McGUIRE NUCLEAR STATION, UNIT 1

AMENDMENT TO FACILITY OPERATING LICENSE

Amendment No. 99
License No. NPF-9

McGUIRE NUCLEAR STATION, UNIT 2

Figure 3/4 7-1

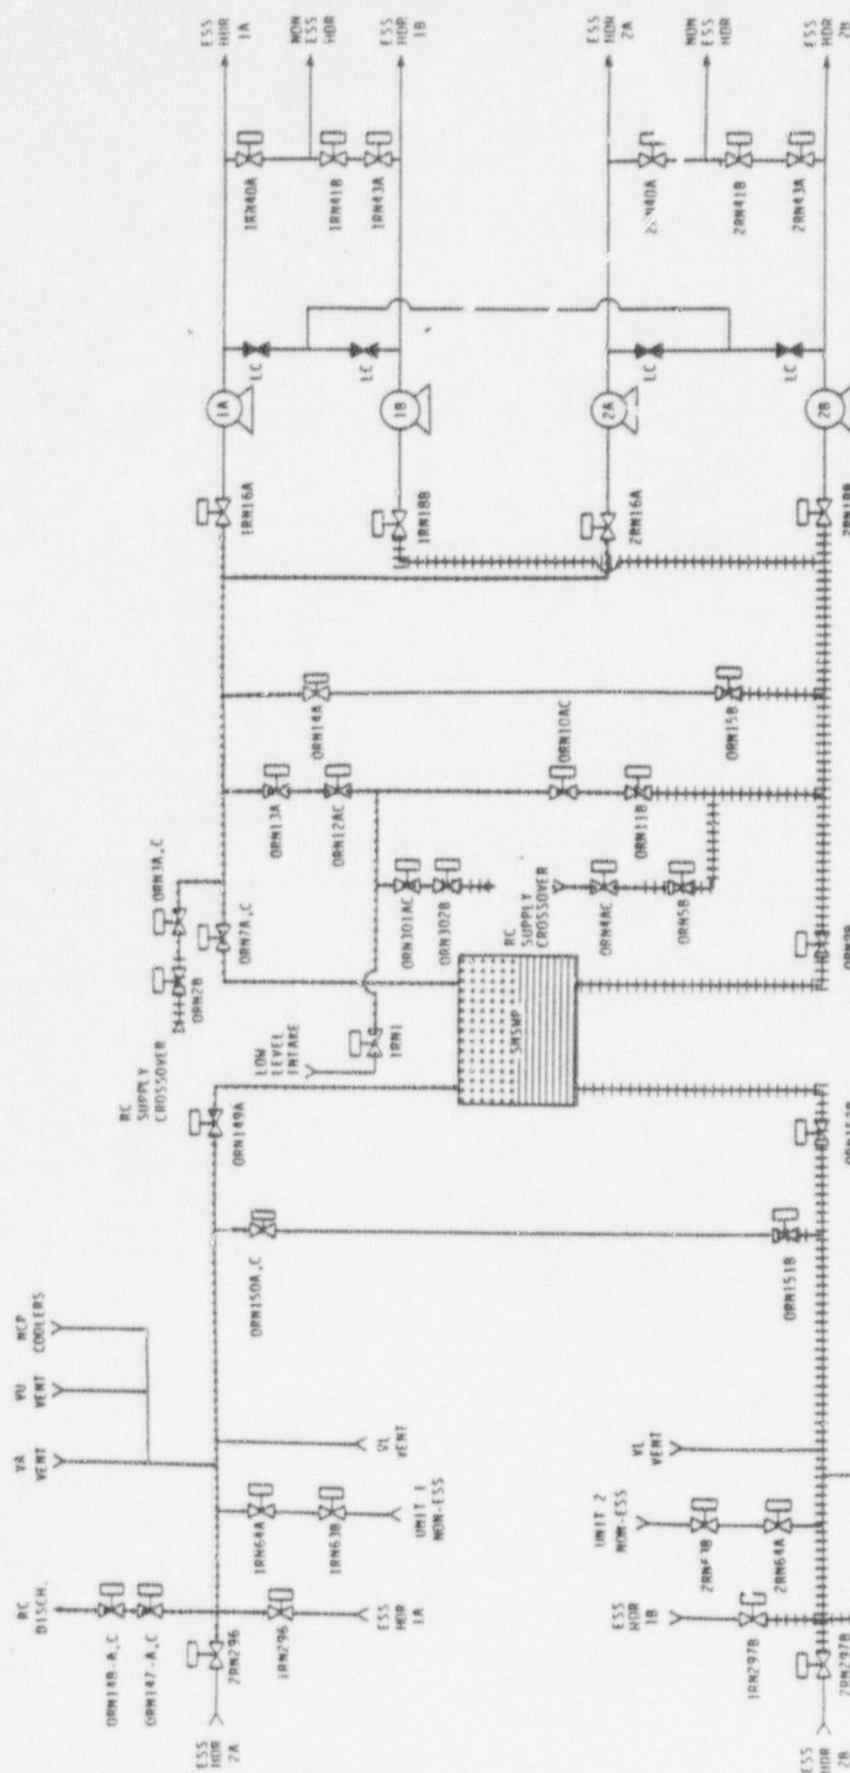
Replace the following pages of the Appendix "A" Technical Specifications with the enclosed pages. The revised pages are identified by Amendment number and contain vertical lines indicating the areas of change.
